July 7, 2009

Re: Comments on Draft Tehachapi Uplands Multiple Species Habitat Conservation Plan, Draft Environmental Impact Statement and Draft Implementing Agreement (74 Fed. Reg. 6050)

These comments are submitted on behalf of the Center for Biological Diversity, Wishtoyo, and Wishtoyo’s Ventura Coastkeeper program.

Cogan Figure 1 on left; DHCP Figure 4-1 on right.

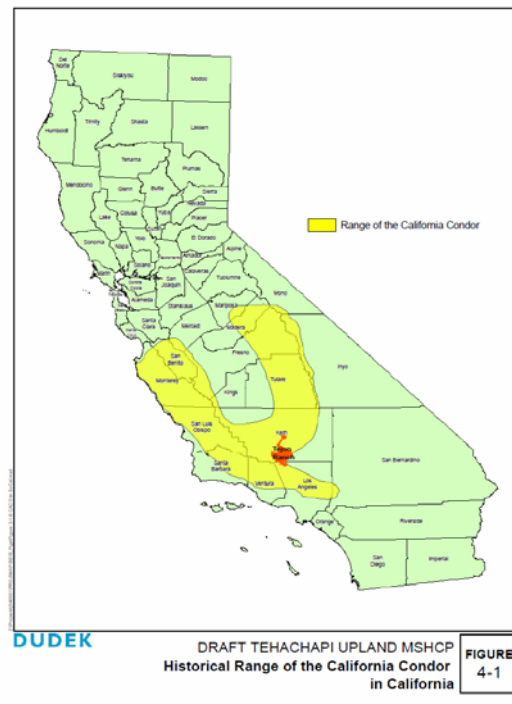
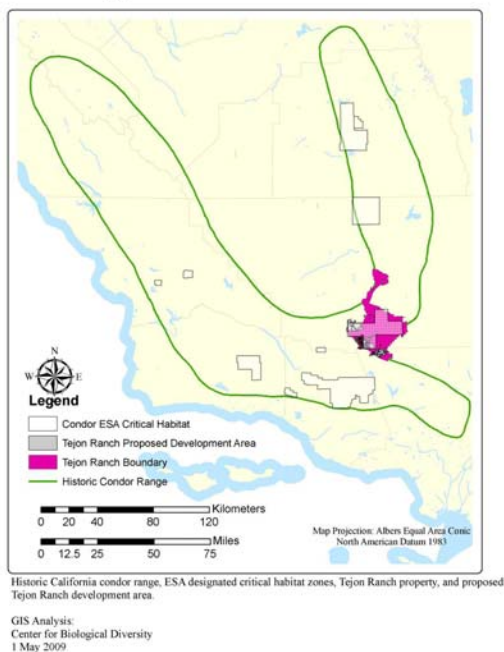
The selective bias of the DHCP and the DEIS is also apparent in the map showing the historic range of the condor (DHCP Figure 4-1, DEIS Figure 3.1-6). Tejon Ranch is represented here as occupying only a small portion of the core, or linchpin, of the “wishbone” of historic condor habitat. Yet this representation of condor habitat is inaccurate: it suggests condor use far into the floor of the San Joaquin Valley. The DHCP itself admits that condors have not, and do not, utilize the valley floor to any significant extent (DHCP pp. 4-9 and 4-66). An accurate portrayal of historic condor habitat, as is found on page 3 of the 1996 Condor Recovery Plan and in Figure 1 of the Cogan report, reveals a far closer relationship between Tejon Ranch and the center of the “Y” of historic habitat:

Rather than the apparently-insignificant relationship represented in the DHCP and the DEIS, the ranch actually spans the entire habitat range—it is the entirety of the core connecting property. And the three development proposals, not shown in Fig. 4-1, substantially block the entire span of habitat (Cogan 2009, Figure 1).

Cogan Figure 3 on left; DHCP Figure 4-7 on right.

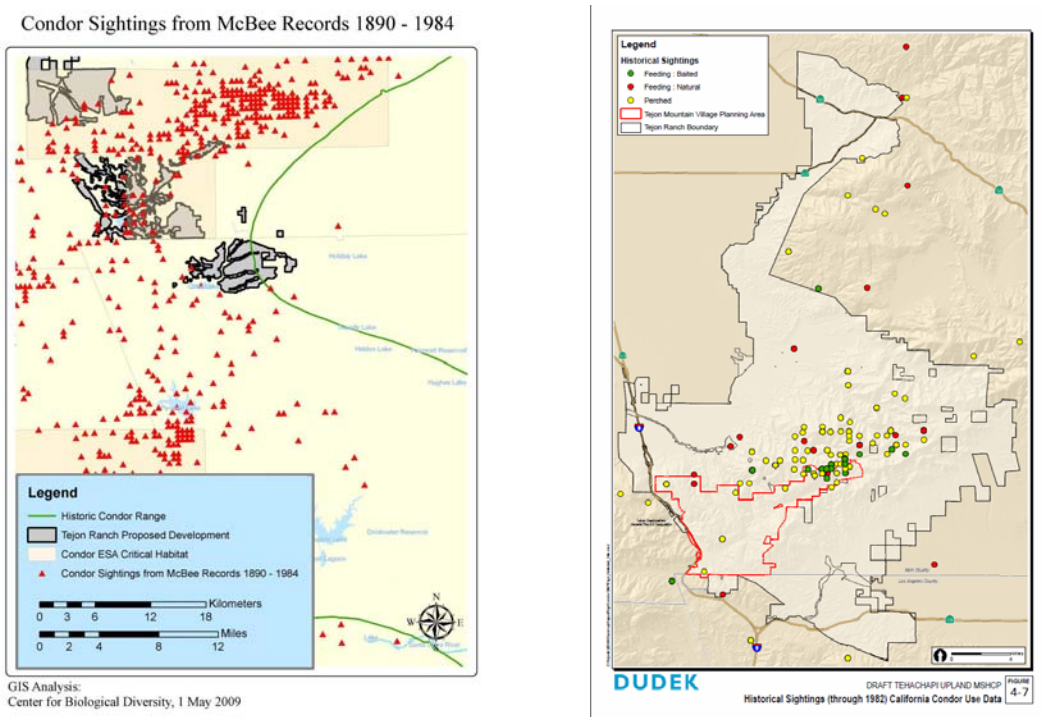
Other potential sources for the misinterpretation of data can be found in the various attempts to convey the condor point data. The interpretation of this data, and the conclusions drawn from it, are discussed in more detail below, but some discussion of the mapping in the DHCP and the DEIS itself is warranted here. First, only one of the figures in the DHCP that contains condor point data also shows the boundaries of critical habitat (Figure 4-10). Considering the legal and scientific importance of designated critical habitat, all maps in the DHCP and DEIS dealing with condors must include the boundaries of its critical habitat. Second, little to no detailed information is provided regarding the data represented in the maps. Although the reader is informed that some points represent aerial, perched, or roosting condors, more detailed information is generally not provided, such as the total number of birds represented in the data and the specific mechanisms of data collection. This information is critical to understanding the differences in mapping results within the DHCP and the DEIS, as well as comparing these results with those in the Cogan report. For example, Figure 4-7 in the DHCP appears to show very little historical use of the TMV area, at least through 1982. Although the legend states that the points represent feeding and perch activity, no further details are provided. This map stands in significant contrast to Figure 3 of Cogan's report, which shows heavy use of the TMV area through 1984, using virtually the same set of data:

It is possible to conclude that the difference between these two maps may be the result of the exclusion of condor flight observations from Figure 4-7, although this is not clear because of the lack of explanation and information of the data set presumably used in Figure 4-7. In addition,

there is no explanation why the data set used in the DHCP only goes until 1982, when the data set obtained by the Center covers through 1984.

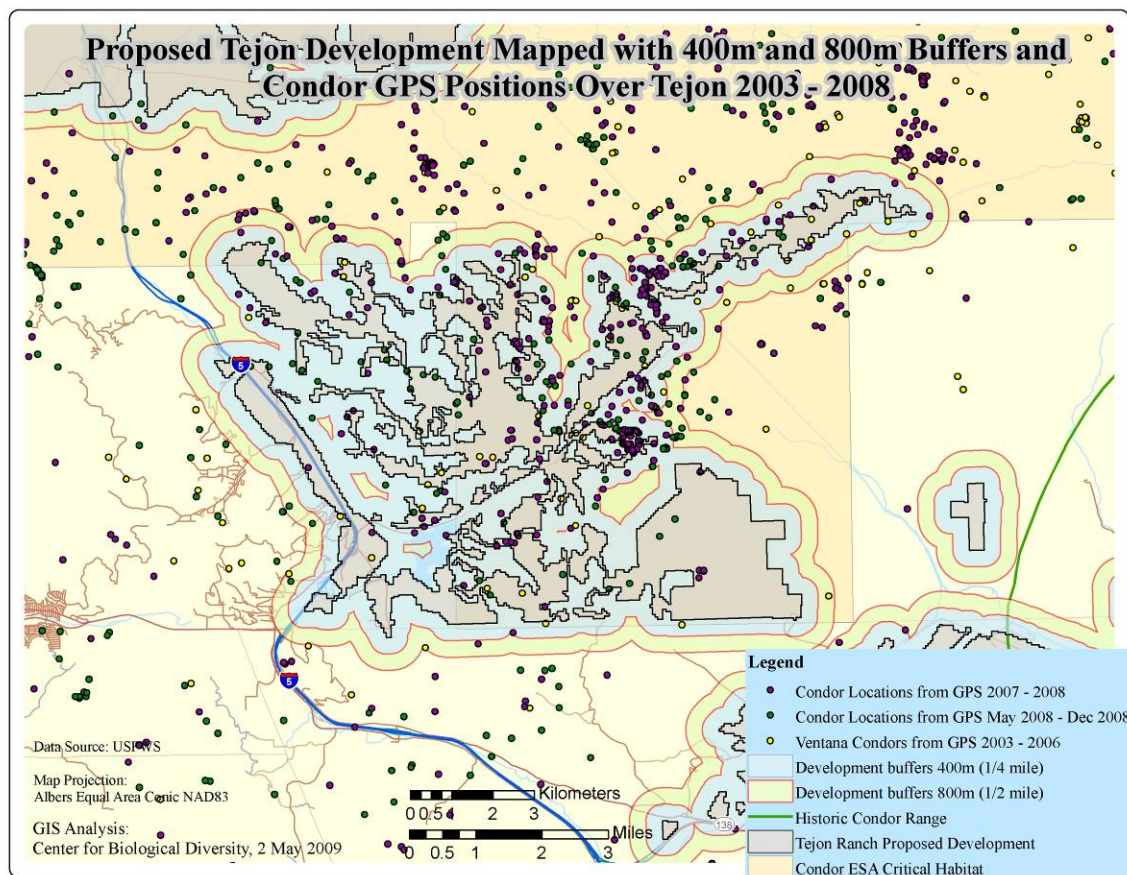
This is especially true, as described in Cogan's report, in a fragmented development scheme like TMV (Cogan 2009, Figure 15). The DHCP's failure to consider buffers for either the individual data points or for the development area thus renders its analysis and conclusions fatally flawed.⁵

Even if one were to accept some aspects of the habitat suitability model, however, it is difficult to see how the DHCP could arrive, based on the data and maps provided, at a figure as small as 1,337 acres of suitable condor habitat being lost by the project. Not only is this figure not adequately supported or described, but it begs credulity given the size of the TMV project, which calls for at least 7,860 acres of impacted lands out of a total 26,417 acres of the TMV Specific Plan.⁷ DHCP pp. 2-2 and 2-11. Furthermore, it fundamentally understates the actual impact of the development project on foraging habitat: rather than being limited to the actual square footage and acreage of buildings, driveways, swimming pools, tennis courts, etc..., the impacted area *must* include a buffer; condors are simply not going to forage in the grass strips alongside driveways and roads and other lands (even naturally vegetated) just across property lines. And even if they were, they are extremely unlikely to find any carcasses within sight—or smell—of a residence or other human activity (Cogan 2009, Figure 15).
